Farmington Field **SUNDRY NOTICES AND REPORTS ON WELLS**  
Bureau of Land Management **Do not use this form for proposals to drill or to re-enter an  
abandoned well. Use Form 3160-3 (APD) for such proposals.**

**San Juan 29-7 Unit 65M**

Burlington Resources requests permission to plug back the Dakota zone and produce this well as a standalone Mesaverde well. See the attached procedure, current and proposed wellbore diagram. A Closed loop system will be utilized to plug back the DK zone.

**Schematic - Proposed  
SAN JUAN 29-7 UNIT #65M**

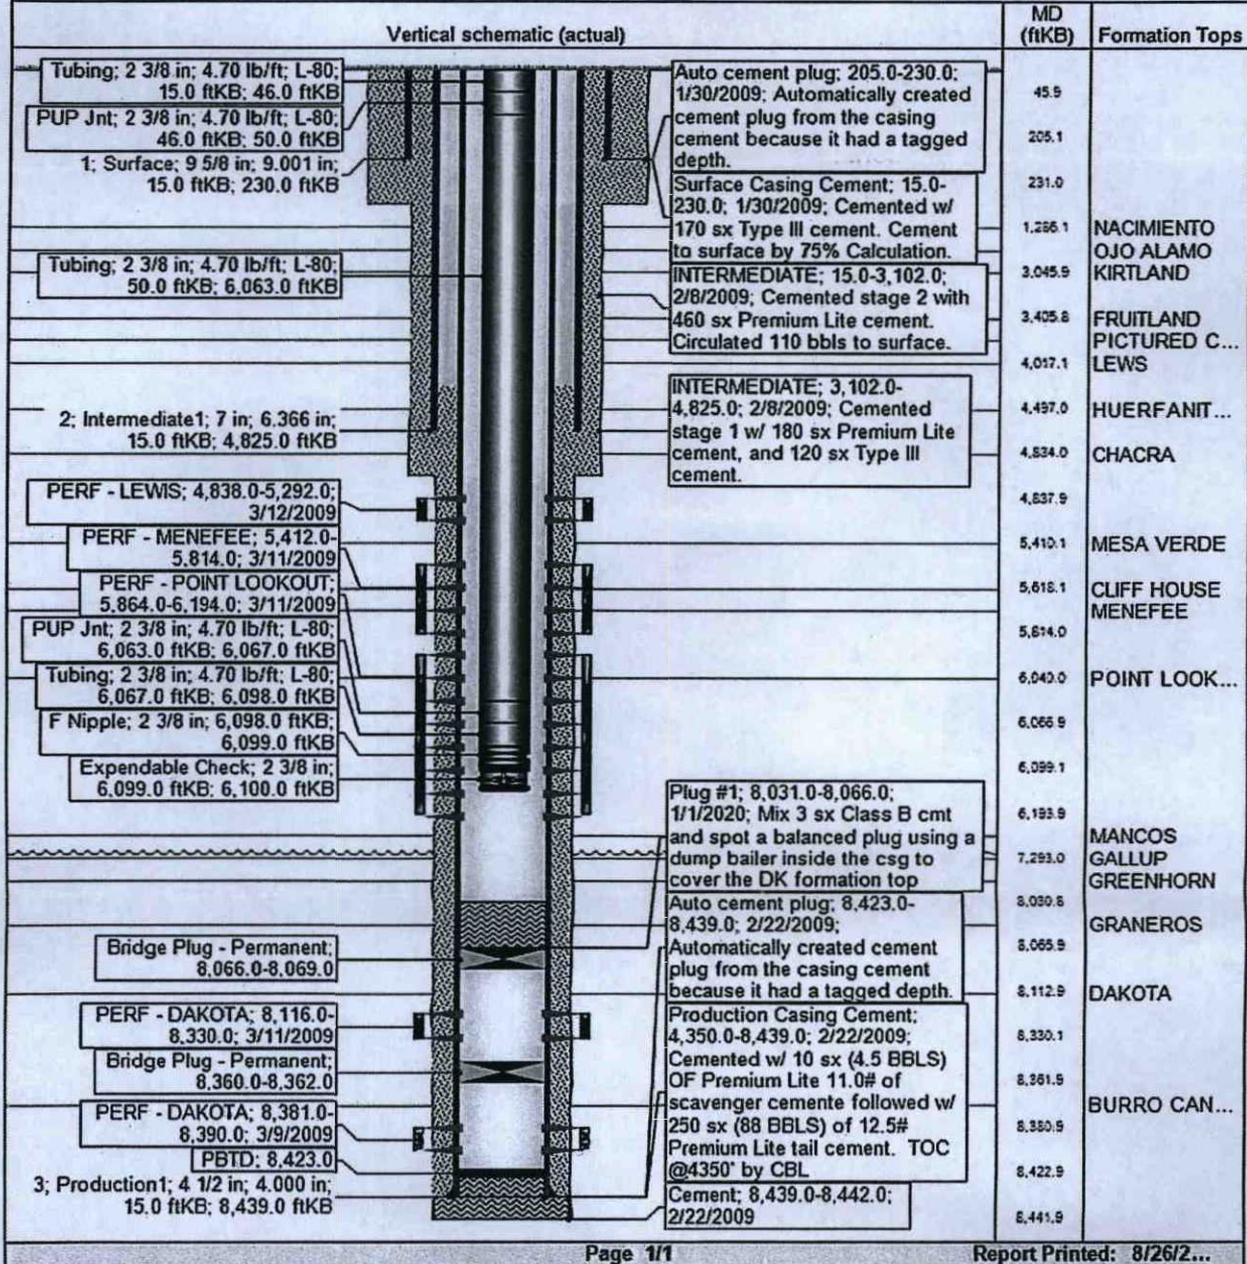
8. **Plug 1 (Dakota and Graneros Formation top and Dakota Perforations, 8,031'-8,066', 3 Sacks Class B Cement mixed at 15.6 ppg with a 1.18 cf/sk yield)**  
 Mix 3 sx Class B cement and spot a balanced plug using a dump bailer inside the casing to cover the Dakota formation top. POOH.
